Public Service Commission

May 10, 2010

The Reclamation Division has reviewed DWC's response to our September 16, 2009, technical review of Revision 25 to KRSB-8802. The following issues must be addressed prior to this office recommending Commission action. Considering the renewal and associated revision that needs to be submitted for this permit and the need to begin grading work in the final pit area, please respond to this letter no later than June 1, 2010.

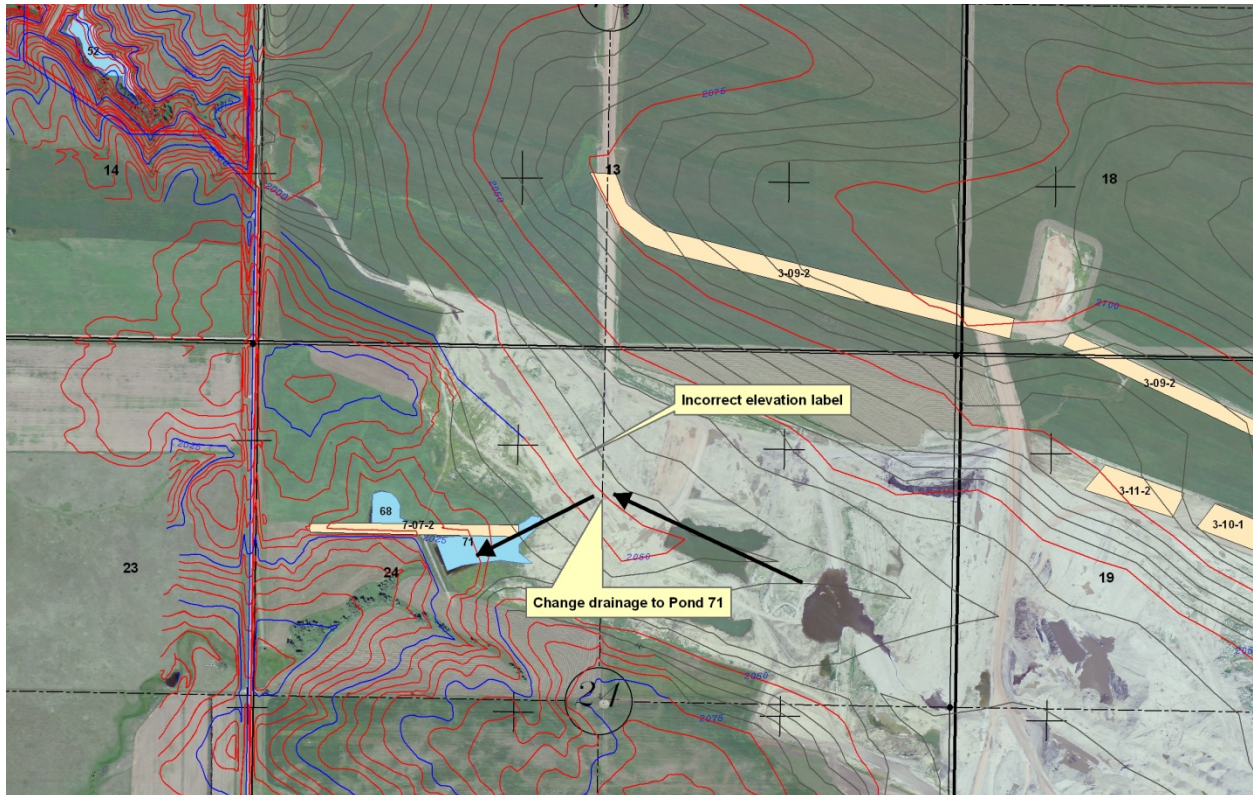
8. Follow-up to Item No. 10: The contour elevation line near the drainageway in the N½ of Section 24 is mislabeled on the Contour Map of Post-Mining Topography, Exhibit 3.5.3, as 2050 when in fact it is 2025. The Reclamation Division believes that runoff from the NE¼ of Section 24 should be directed to Pond 71 rather than towards Pond 52. This will create a watershed break where the long flat channel is proposed and the pre-mine watershed for the undisturbed drainageway in the NW¼ of Section 24 will be more similar to the pre-mining conditions. Please revise Exhibit 3.5.3 and all associated exhibits accordingly. See image below. The surface water PHC may also have to be updated as well. (GAW)
